SIGAR 19-16 Inspection Report

Marshal Fahim National Defense University: Phase III Construction Generally Met Contract Requirements, but Five Deficiencies and Inadequate Maintenance Increase Safety Risks for Building Occupants

JANUARY
2019

Photo 5 - Welded Propane Gas Supply Pipe Outside the DFAC Kitchen

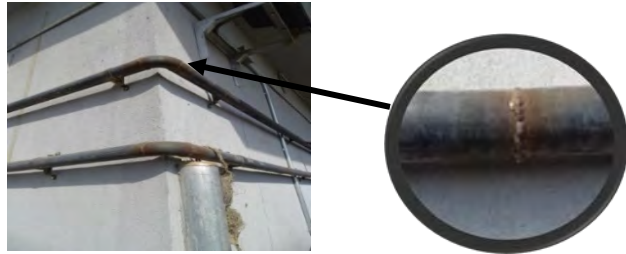
Assist Consultants' contract required the company to install 50-millimeter propane supply gas pipes in the DFAC. The NFPA requires pipes measuring 50 millimeters or less to be connected with threaded fittings.¹⁴ During our site visits, we found that Assist Consultants installed 50-millimeter propane supply gas pipes as required, but it welded the pipes together instead of using threaded fittings as required (see photo 5). In August 2018, USACE said its gas pipe installation met NFPA 58 requirements and was not a safety issue. However, we responded that the welded fittings do not comply with NFPA, which requires threaded fittings for pipes measuring 50 millimeters or less. These welded connections create a safety risk for personnel in the DFAC because the welded connections are more likely to form pores, or pinhole gaps, that result in gas leaks, which could cause an explosion and fire.

USACE stated that it agreed that the contract required DFAC propane supply pipes 50 millimeters or smaller to be threaded, but that the pipes installed were welded instead. USACE stated that although the contractor did not meet contract requirements, it did meet another NFPA code requirement for pressure testing of pipes. USACE added the propane system met this code because it was pressure-tested, no leaks were detected, and it does not pose any safety hazards. However, USACE did not provide any documentation of pressure testing during our inspection and in its comments. As a result, we maintain that these noncompliant pipes do pose a safety hazard.

SIGAR's draft report indicates non-compliant connections on the dining facility propane supply pipes were installed by welding the pipes together instead of using threaded fittings as required. SIGAR is correct in that according to the contract all propane supply lines 50 mm or smaller should have threaded connections and not welded connections. The drawings indicate all propane supply lines outside of the building are 50 mm or smaller and were welded and not threaded connections. Although the performance of the contractor did not specifically meet the contract, the contractor did meet the code requirements of the National Fire Protection Association (Paragraph 6.11.3.5 and Table 6.11.3.5A) for piping under pressures of 125 psig (which applies to the system installed). During installation the propane system was pressure tested and no leaks were detected. As installed the system meets code requirements and does not pose any safety hazards.
